FSC 22-13-2479 HV Interlock Loop Update

Field Service Campaign

Gen2.0 and Gen2.5 BEB PTC compartment HV battery cables may have insufficient support bracketry that could allow a potential HVIL error fault.

REMOVE/UNINSTALL HV CABLE AND SUPPORT BRACKETS

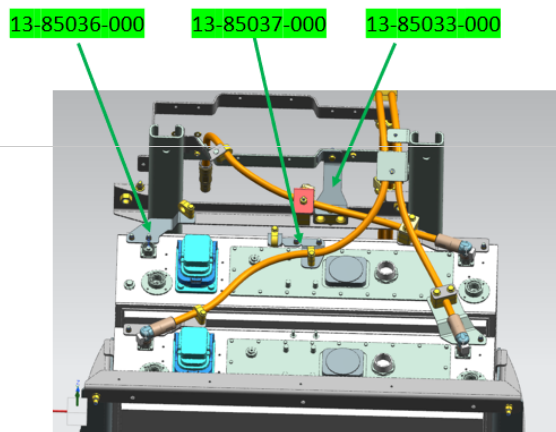
- Step1- Remove HV cable 50-81923-002
Step 2-Remove bracket#13-81350-000 and #50-81352-001

INSTALL CABLES AND CLAMPS GEN2.0

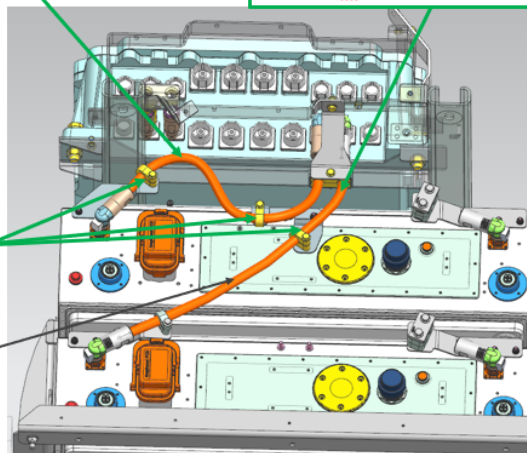
Step 5- Install HV cables 50-81923-000 as shown in Image. Note the orientation of clamps in below image. Ensure smooth bends adjust cable between clamps as needed

New cable 50-82631-020

Clamp #13-81319-001
Support plate #13-85044-000
Bolt #54-11316-007
Washer #54-12600-006
Torque 8 ft-lbs with Loctite

Clamp #54-15400-442
Bolt #54-11316-006
Washer #54-12600-006
Torque 2 ft-lbs with Loctite

Cable #50-81923-000 already installed on bus. Just change clamps on this cables as per image

REMOVE/UNINSTALL HV CABLE AND SUPPORT BRACKETS

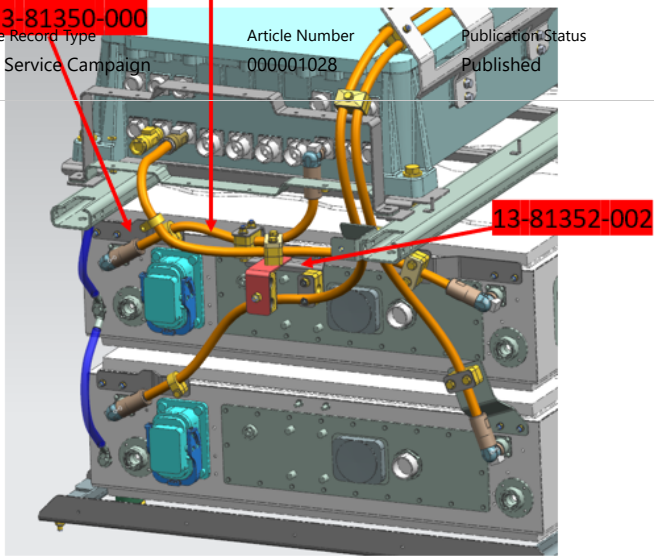
Step1- Remove HV cable 50-81923-002

Step 2- Remove bracket#13-81350-000 and #50-81352-002

INSTALL NEW SUPPORT BRACKETS

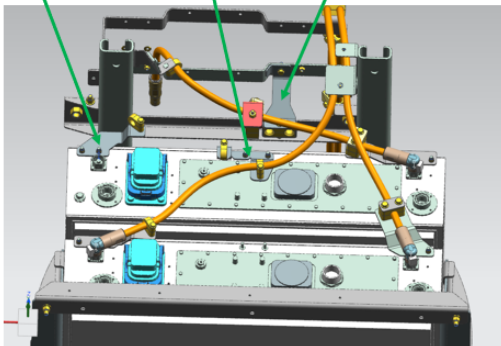
Step 3- Install bracket #13-85036-000 and 13-85037-000 on Top PTC Battery as shown in image.

Use Hardware# 54-13108-084, 54-13112-082-Torque spec 5.2 ft-lb with Loctite

Step 4- Install brackets #13-85033-000 on PTC RACK Bracket 13-81379-002 (already installed on bus). This step requires match drilling on bracket 13-81379-002. Flush the faces of bracket #13-85033-000 and Bracket 13-81379-002 as shown in image below and drill .40" diameter hole in bracket 13-81379-002.

Use hardware- BOLT#54-11318-003, WASHER# 54-12600-007 and nylock nut 54-12540-006. Torque spec 15 ft-lbs.

Install cables and clamps GEN2.5

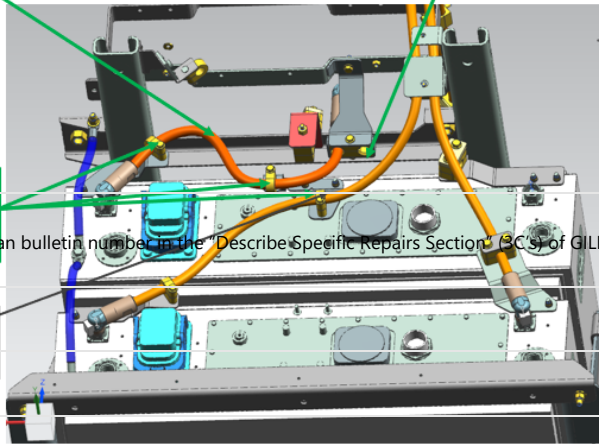
Step 5- Install HV cables 50-82631-020 as shown in Image. Note the orientation of clamps in below image. Ensure smooth bends adjust cable between clamps as needed

Clamp #13-81319-001

Support plate #13-85044-000

Bolt #54-11316-007

Washer #54-12600-006

Torque 8 ft-lbs with Loctite

New cable 50-82631-020

Clamp #54-15400-442

Bolt #54-11316-006

Washer #54-12600-006

Cable #50-82631-000 already installed on bus. Just change one clamp on this cables as per image
